Report Amended by Staff 3/7/84  
Report Amended by CPC 3/8/1984  
**CITY PLANNING COMMISSION**

APPLICATION: 1. Environmental Determination  
2. Plan Review of 328-unit apartment complex on two parcels totaling 21± acres in the R-2A-R zone.

LOCATION: Northwest corner of Mack Road and Franklin Boulevard

re: P84-069 Plan Review to construct 328-unit apartment complex on 2 vacant parcels totaling 21-plus or minus acres in the Garden Apartment-Review (R-2A-4) zone. Loc: NW cor. Mack Rd. & Franklin Blvd. APN: 119-070-38,39

**AMENDED  
EXHIBIT A**

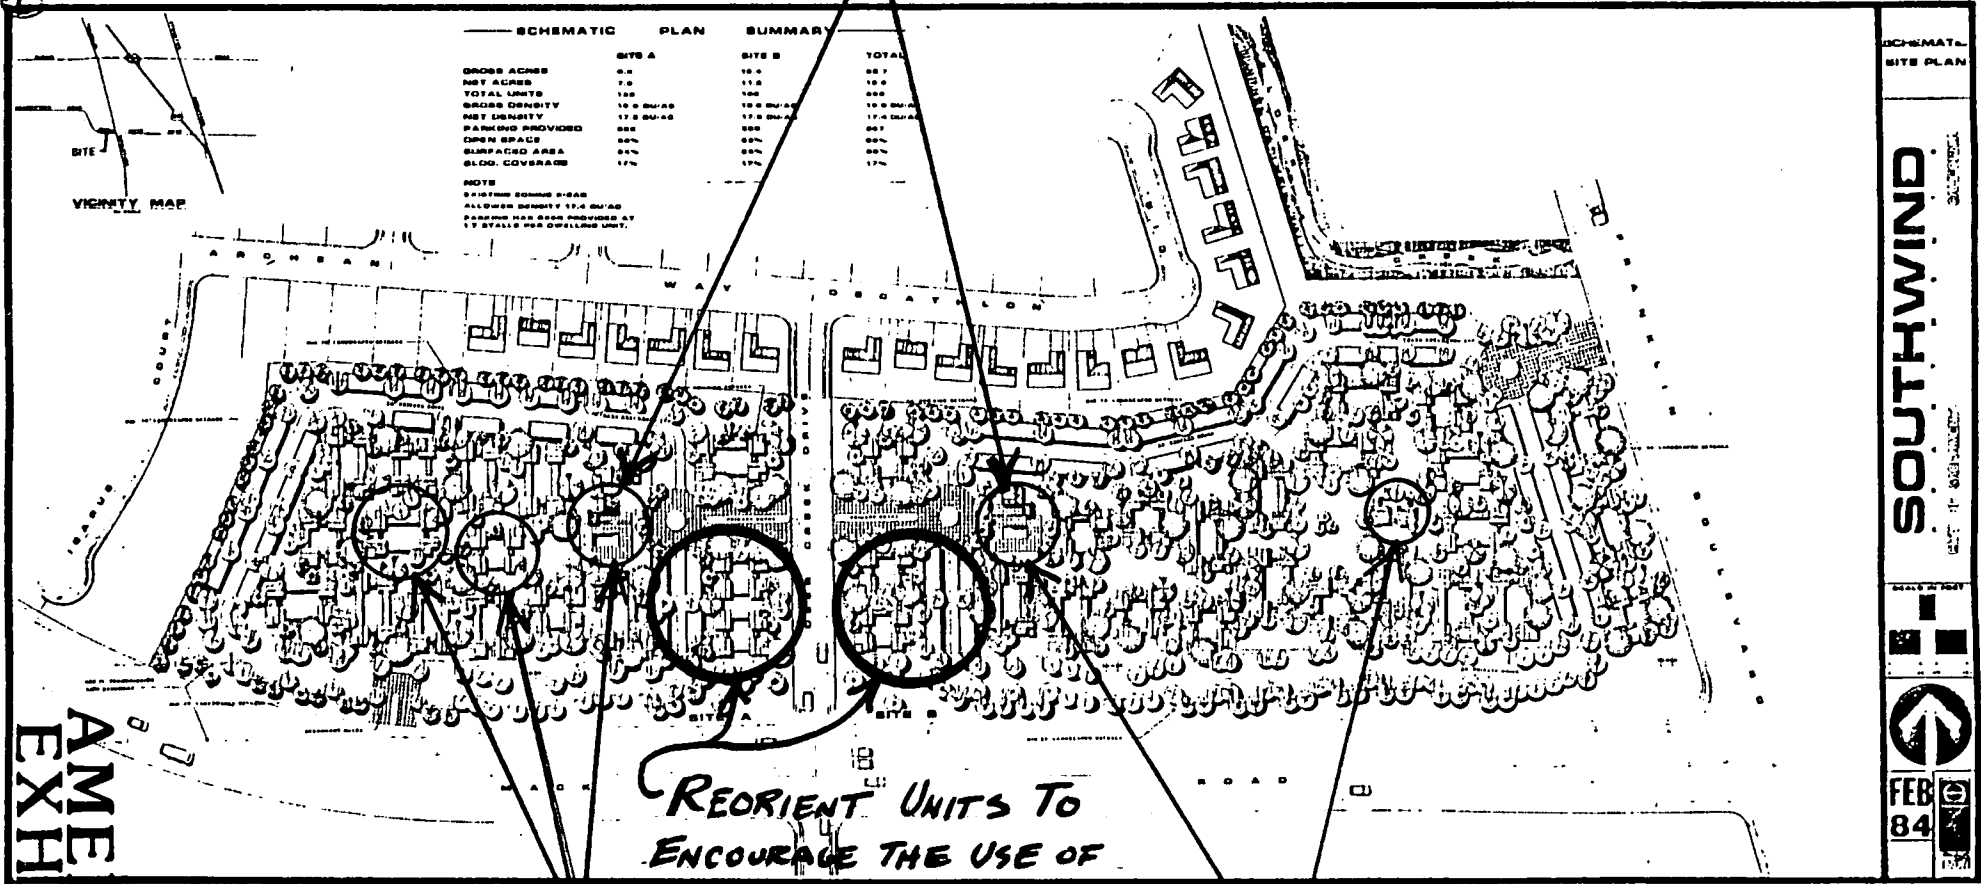
The site plan (Exhibit A) proposes several apartment clusters in the middle of each site which are located a considerable walking distance from the off-street parking spaces. As currently proposed, the distance between these units and the nearest parking spaces range from 120 to 150 feet.

Staff recommends that the applicant redesign the site plan which provides more convenient parking to the apartment units. One possible modification is to switch the location of recreation facility planned at the main entrance to each complex with the apartment clusters. This modification has the additional benefit of providing the recreation facility central to all the apartment units.

*REORIENT UNITS TO  
ENCOURAGE THE USE OF  
OFF STREET PARKING*

**MODIFY SITE PLAN BY SWITCHING LOCATIONS  
OF APT. CLUSTERS WITH RECREATION FACILITIES**

- a. The applicant shall submit the revised final site and building plans to the Planning Director for review and approval prior to issuance of building permits. The revised site and building plans shall include the following modifications:
  - 1) ~~provide access and more convenient off-street parking to cluster units by switching the location of the recreation facilities planned at the main entrances to each complex with the apartment clusters as shown on amended Exhibit A, or an alternative solution, to the satisfaction of the Planning Director; DELETED BY CPC~~
  - 2) incorporate turnout lane and tenant directory board at primary entry driveways; 003701
  - 3) ~~the apartment units facing Deer Creek Drive shall be limited to a height of one story; DELETED BY CPC~~

- f. *as indicated on Exhibit A,* Reorient the units along Deer Creek Drive/to discourage the use of on-street parking.
- g. *A childrens' play area shall be provided.*

EXHIBIT B

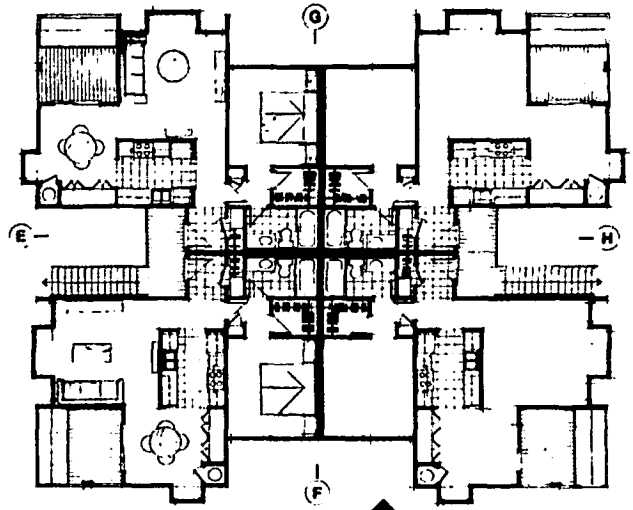
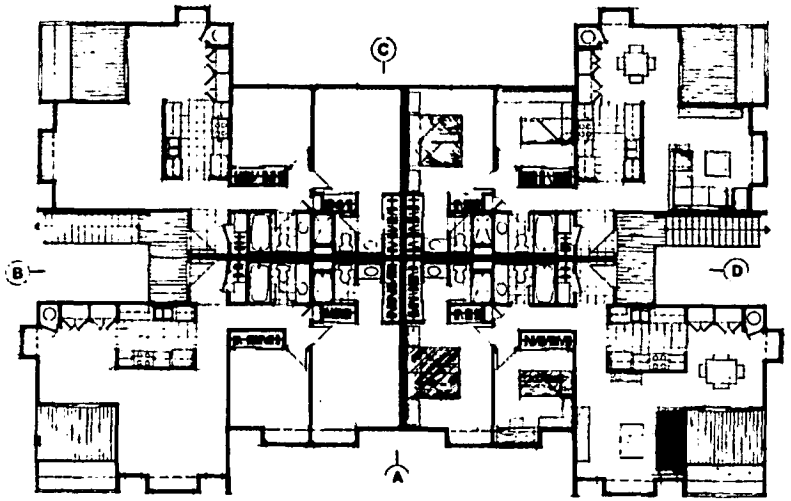
The applicant proposes to develop all two-story apartment clusters with each cluster consisting of eight apartment units. The buildings are to be constructed of T-111 plywood siding, and the proposed design is uniform throughout the project.

Staff has no objection to the overall architecture of the units per se in that the buildings are designed with sufficient relief with the incorporation of bay window elements, balconies and off-set building walls. However, in order to address the concerns indicated by the South Sacramento Advisory Committee, staff suggests the following modifications to improve the compatibility of the subject project with the adjacent single family subdivision to the north:

- b. The applicant proposes to use T-111 plywood siding on all the structures with composition shingle roofing material. As with other large apartment complexes being developed throughout the City, staff is concerned with the homogeneous, one color, one material, one design appearance of these projects.

In order to provide diversity and visual break-up of the massive homogeneous appearance, staff requests that different building and roofing materials, such as stucco, horizontal wood siding, wood shake or shingle, and that more than one primary color be utilized on the project;

- b. The applicant shall utilize more than one primary *exterior* building ~~and roofing~~ material and more than one primary color.\*\* The applicant shall submit a sample board to the Planning Director for review and approval, *of these indicating the exterior building materials and colors* prior to issuance of a building permit;

\*\* *and the roofing shall consist of heavy shadowline material.*
